Review Assessment

South Florida Water Management District's
Central Everglades Planning Project, Section 203
Post Authorization Change Report, Integrated
Feasibility Study and DRAFT Environmental Impact
Statement
(March 2018, Amended May 2018)

May 2018

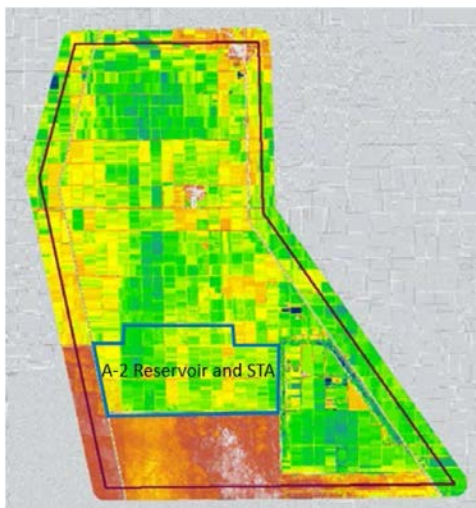
Recommendation for Resolution. A consequence assessment needs to be performed for the proposed water impoundment measures included in the TSP (A-2 Reservoir). The results of the consequence assessment need to be included in the evaluation of the alternative to allow decision makers to determine if the risks of the alternative are tolerable to achieve the proposed project benefits. This includes the communication of the risks to any potentially affected community.

At least a summary of the consequence analysis should appear in the main report and discussion of the TSP. The full results of the consequence analysis should be included in an appendix (likely Appendix E). From ER 1110-2-1156: “Consequences are defined as potential life loss, economic damages, and environmental damages. At the minimum estimate the consequences related to failure of the dam from a breach of the dam with the reservoir at the maximum pool – no spillway discharge, maximum pool with full spillway discharge, and overtopping of the dam.”

SFWMD Response: A concise “consequences assessment” for failure of the proposed A-2 Reservoir is included in Section A.5.1 (Hazard Classification and Emergency Evacuation Requirements) of Appendix A of the CEPP PACR. SFWMD provides the following additional details for your information.

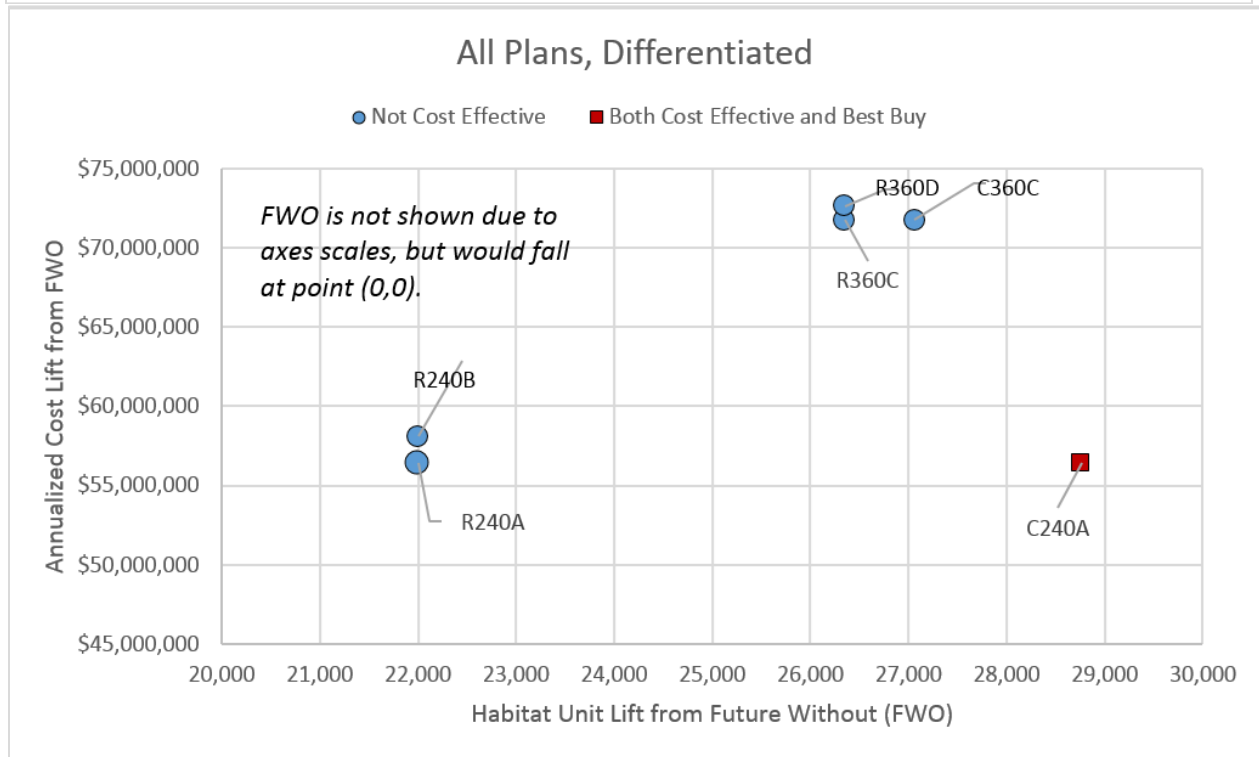
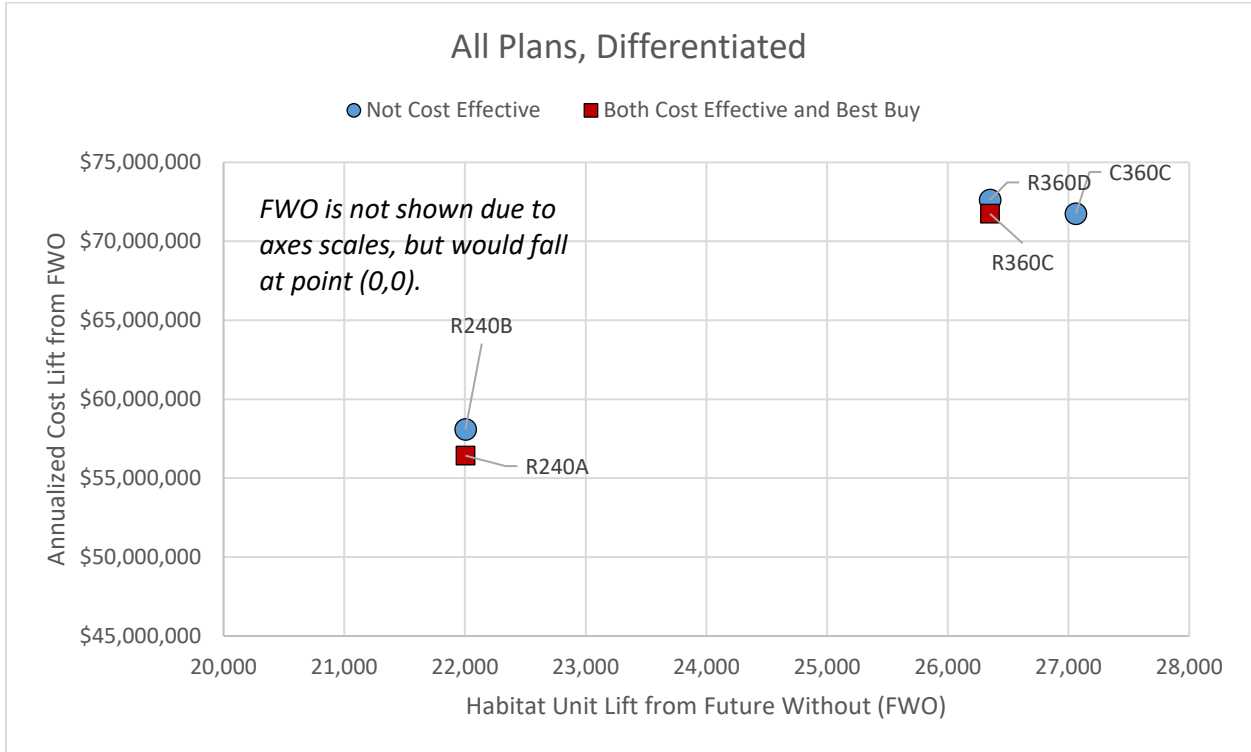
X. CE/ICA Graphic. The results of CE/ICA are not shown graphically. While the overall results shown in Section 4.2.3 and Tables 4-9 and 4-10 appear to be calculated and presented correctly, the cost effectiveness and incremental cost analyses should also be portrayed graphically to aid in decision-making and justification of the TSP.
